### ADDENDUM #3

RE: Solicitation Addendum #3 to RFP #25-01/KVMH Emergency Department Renovation, Phase 3

**EMERGENCY DEPARTMENT RENOVATION**  
 Kauai Veterans Memorial Hospital  
 4643 Waimea Canyon Drive  
 Waimea, Kauai HI 96796

**1 PARTIAL PLUMBING PLAN**  
 M011 SCALE: 1/4" = 1'-0"  
 1/4"=1'-0" 0 1 2 3 4 6 8 22

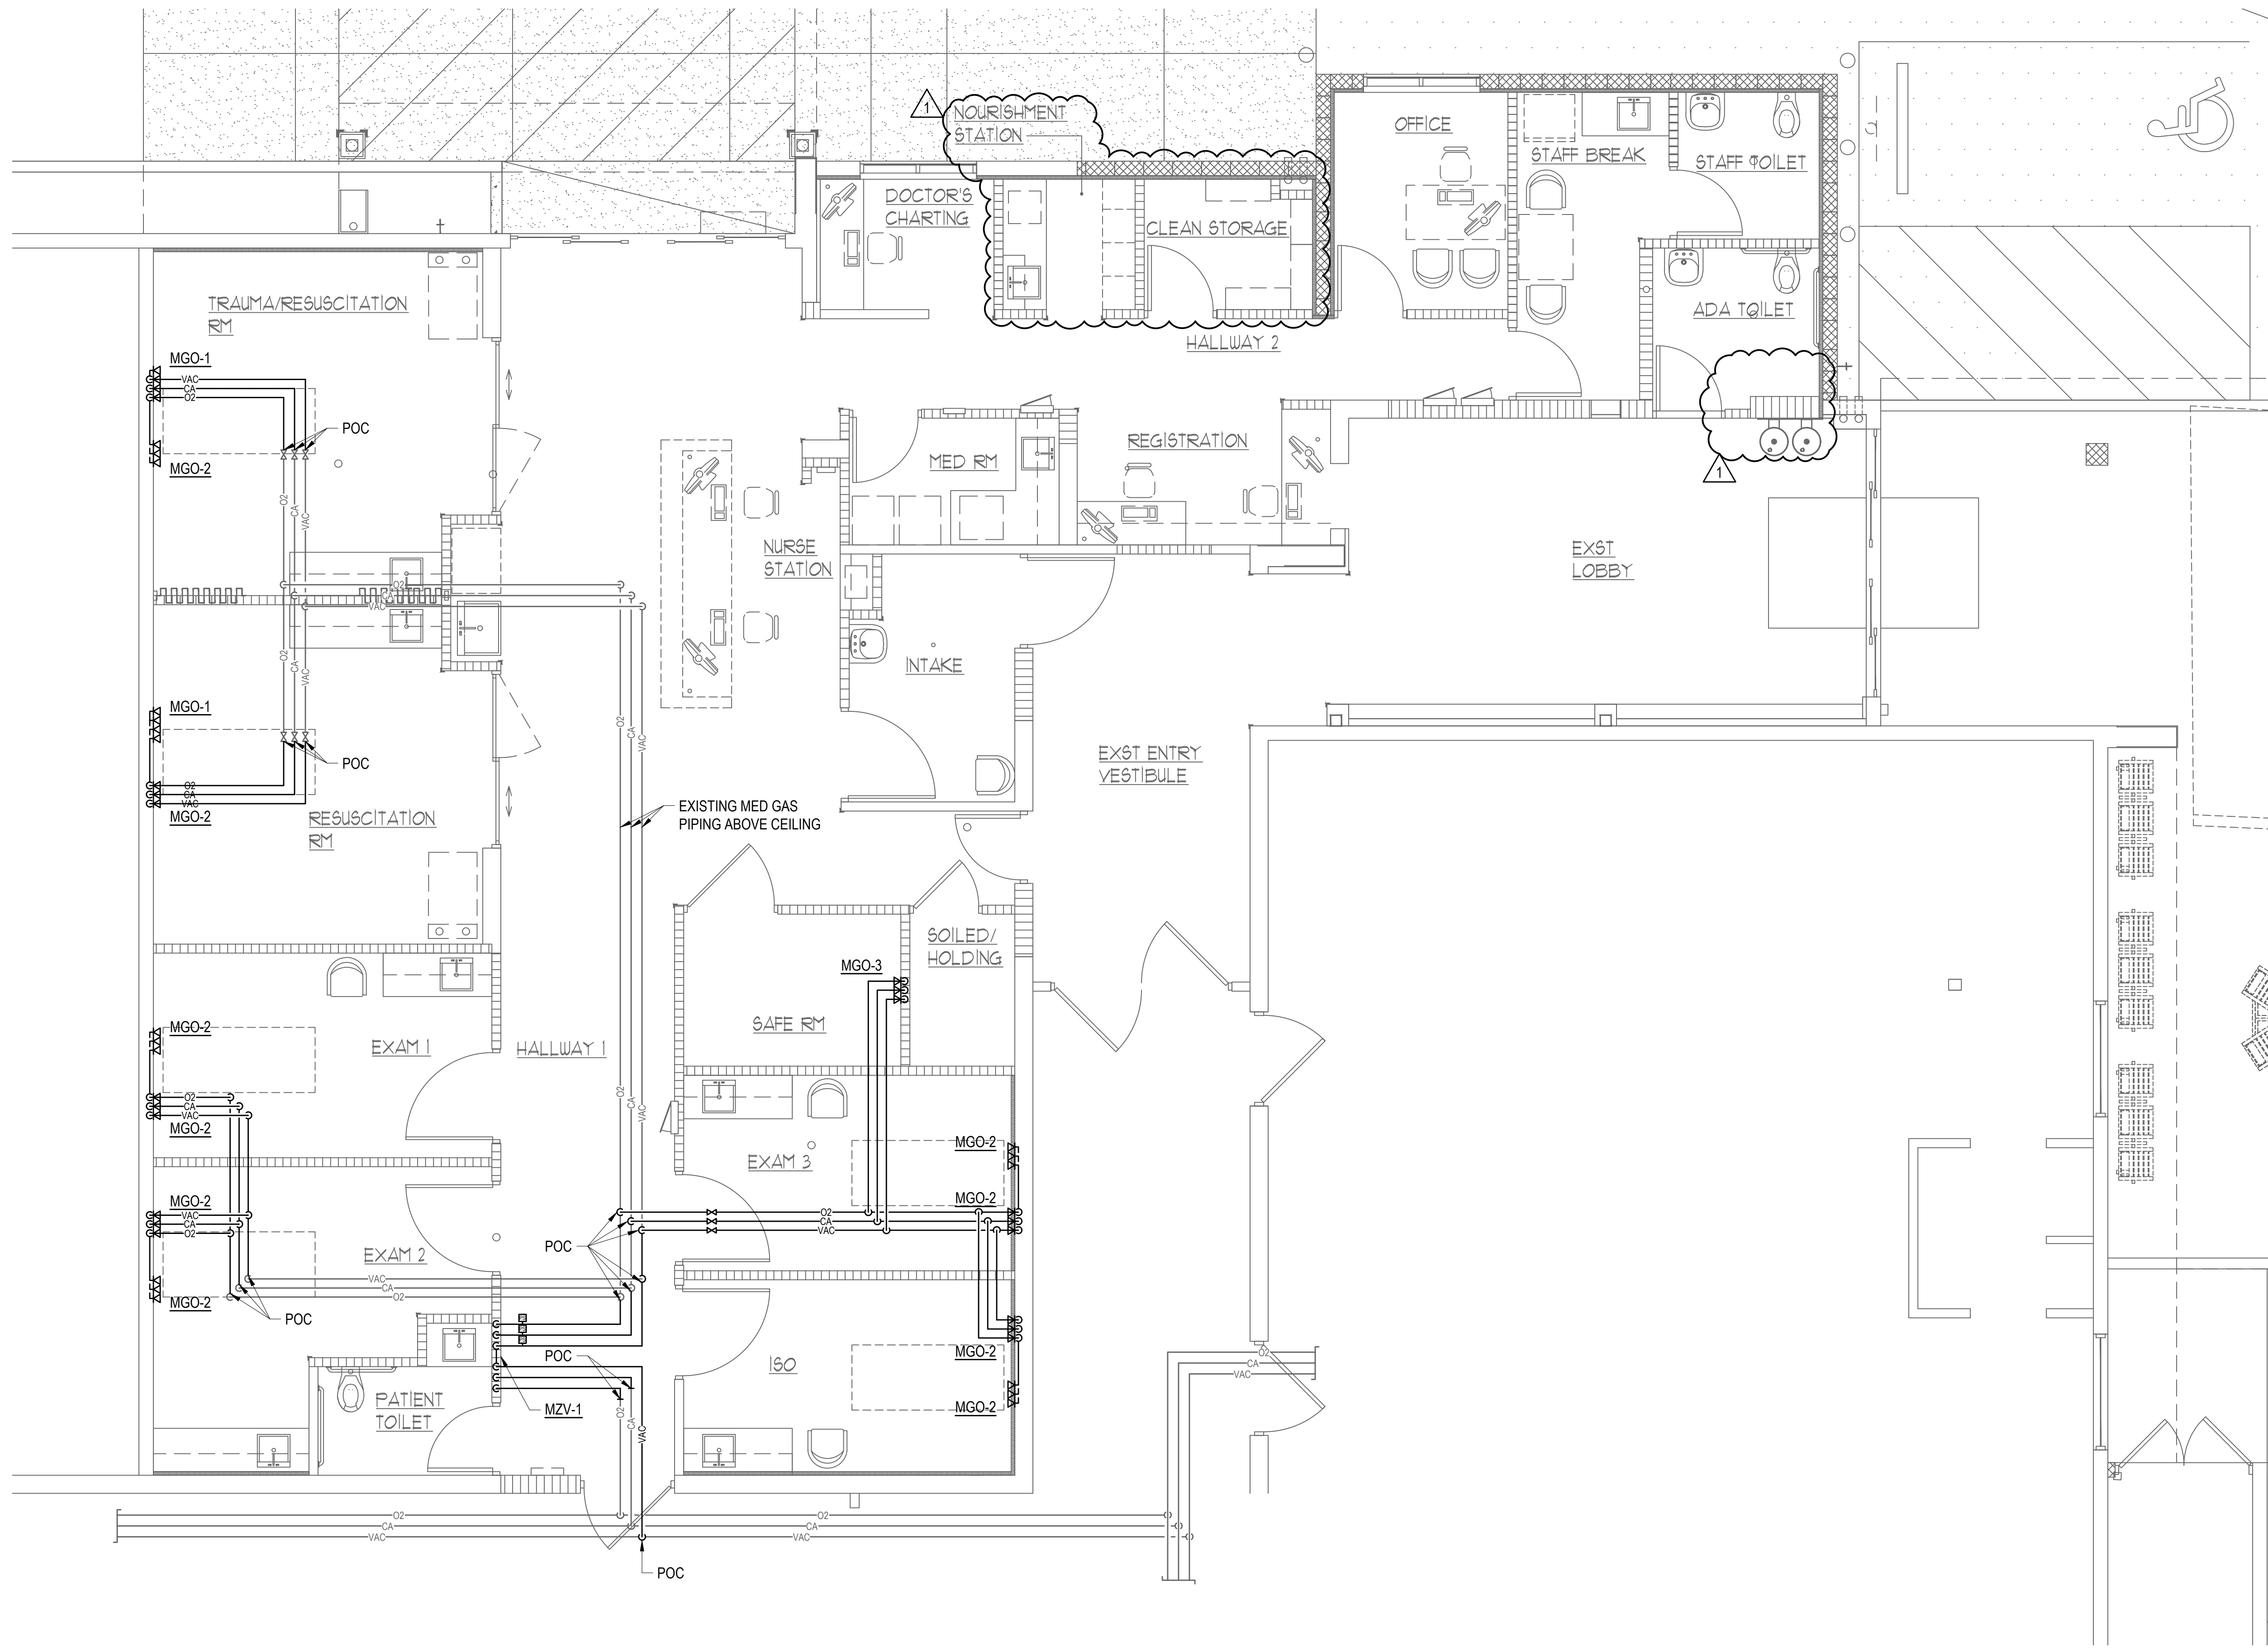
6. Q: Sheet M011 at Existing Lobby show the drinking fountains recessed back in the wall. Architectural sheet A003 new floor plan shows drinking fountains attached to wall that is aligned in plane with new wall and not recessed. Please advise as to which plan sheet is correct.

NOTE: It would be assumed that wall will not be recessed since existing tile will remain and recessed area of the floor will need to patch with existing tile and recessed portion of the wall would encroach on the ADA requirements of the bathroom on the other side.

7. Q: Architectural sheet A003 New Floor Plan at Nourishment Station shows a sink. Plumbing sheet M011 Partial Plumbing Plan shows no sink and room is called 'Clean Storage'. Sheet A003 shows 2 rooms in that location: Nourishment Station and Clean Storage. The same layout discrepancy occurs in the Mechanical Renovation Plan (M009), Med Gas Plan (M012), and Fire Sprinkler Plan (M013). Please advise as to which floor plan is the correct one.

A: [Architectural Sheet A003 is to be followed. Please refer to revised Mechanical Plans attached.](#)

A: [Please refer to revised Mechanical Plans attached.](#)

# PLANTER SLAB

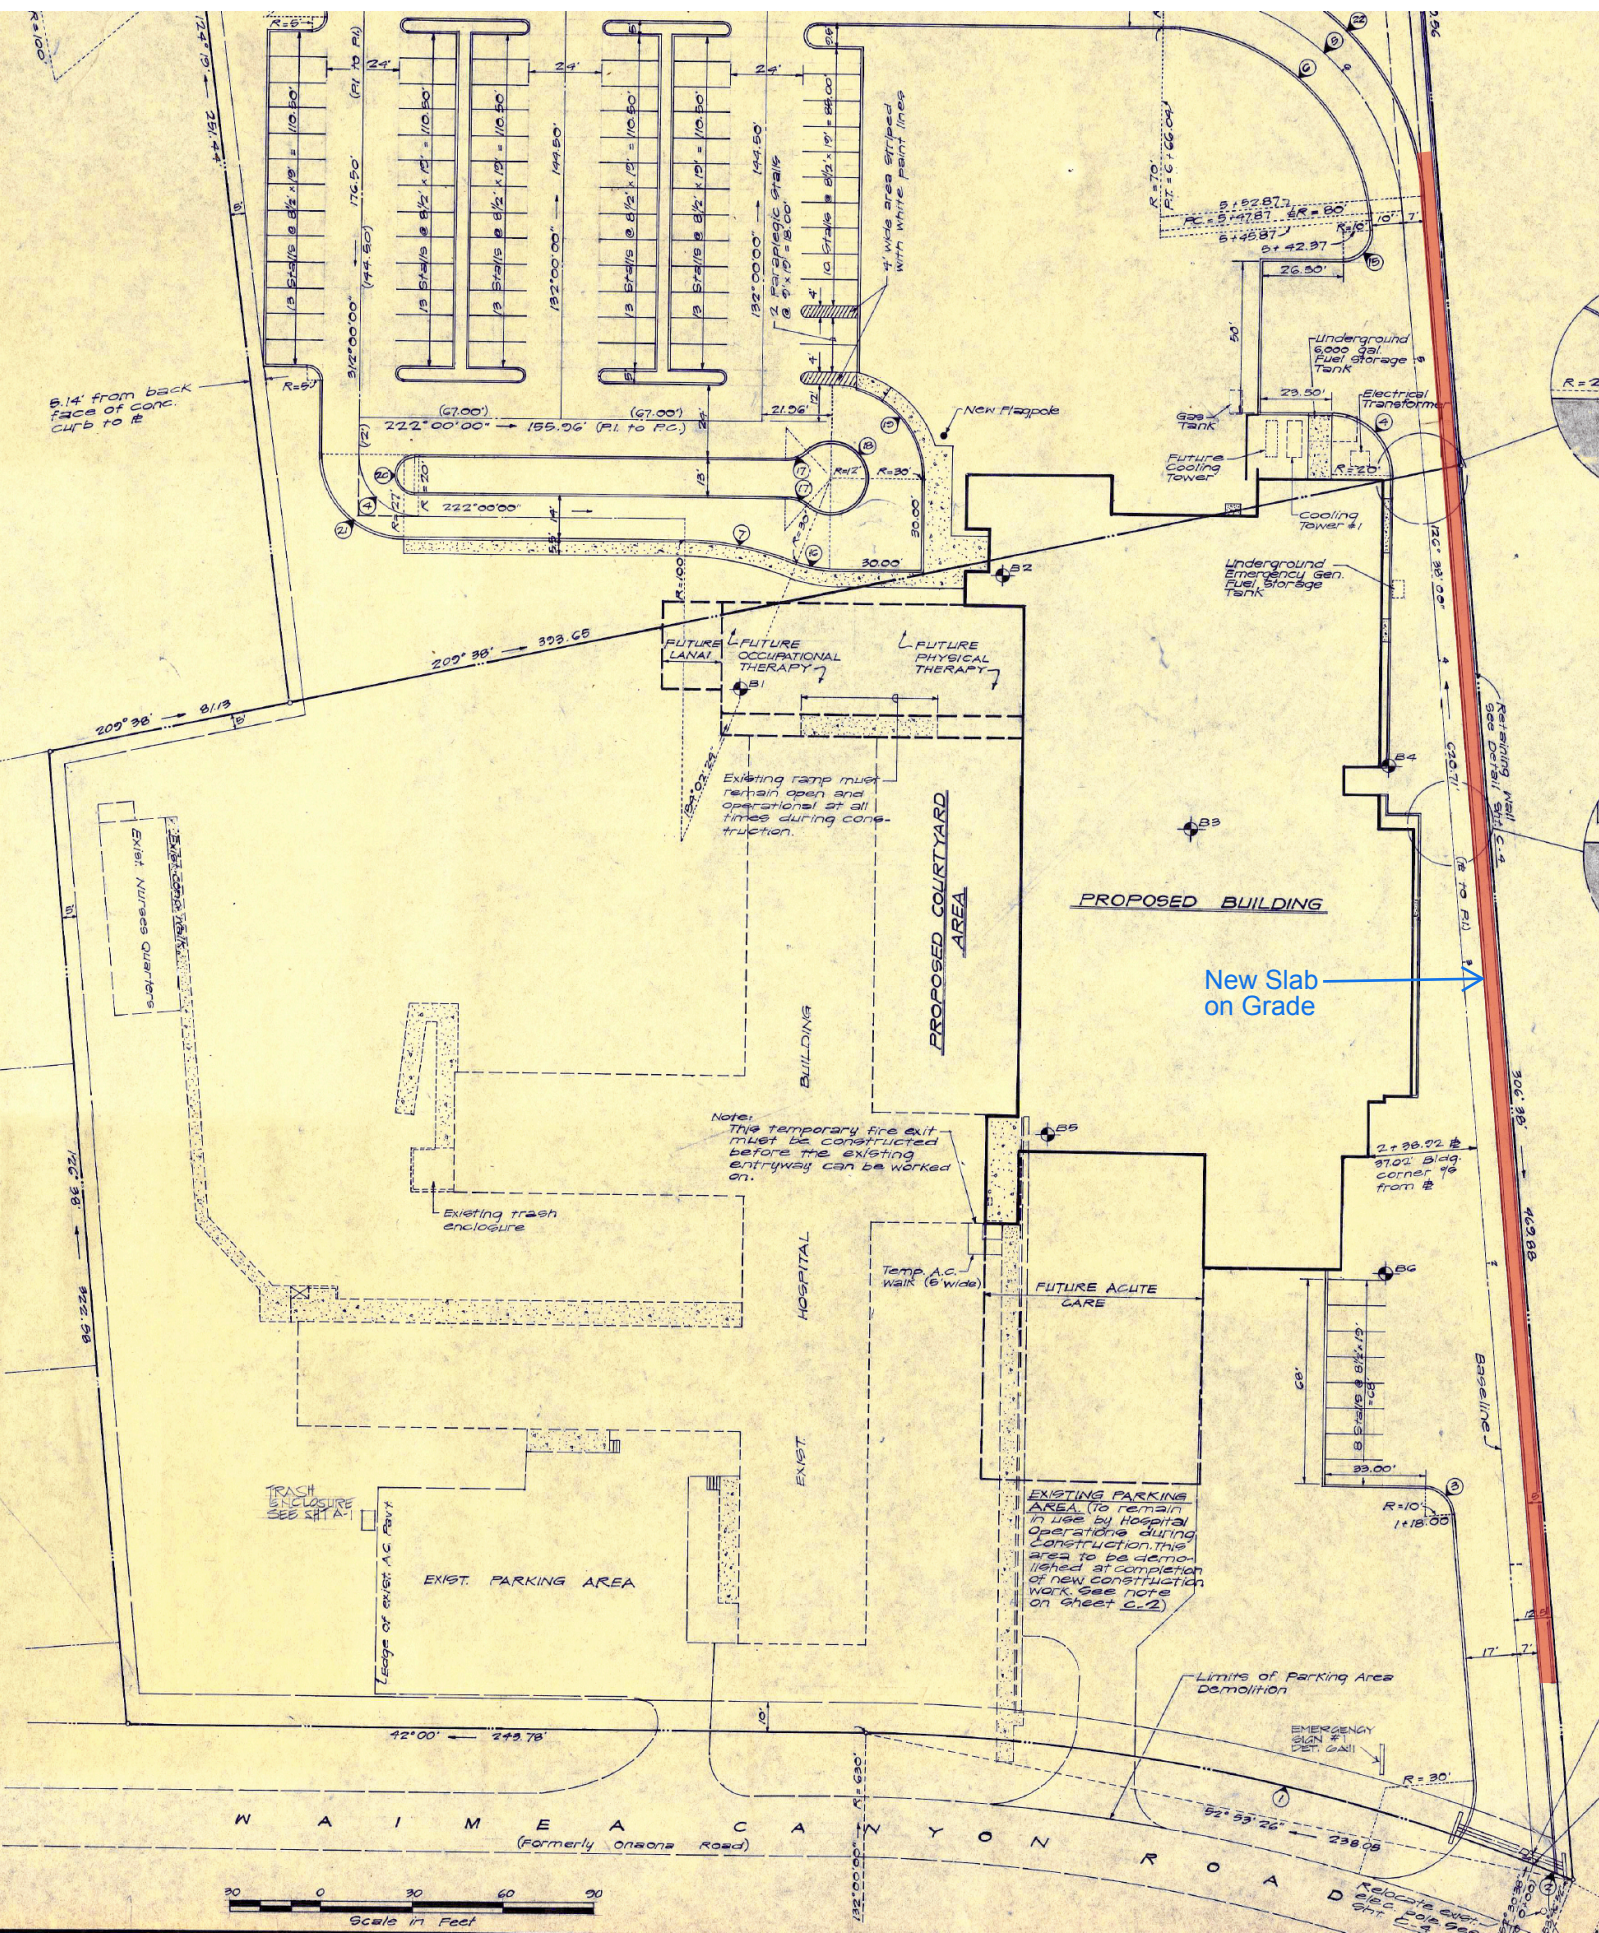
16. Q: On the Civil Drawing C1.0, concrete infill for planter indicates slab on grade from Waimea Canyon Road to end of planter strip. Please clarify/confirm that end of planter strip is at corner of road way.

A: See attached highlighted drawing showing planter infill slab location.
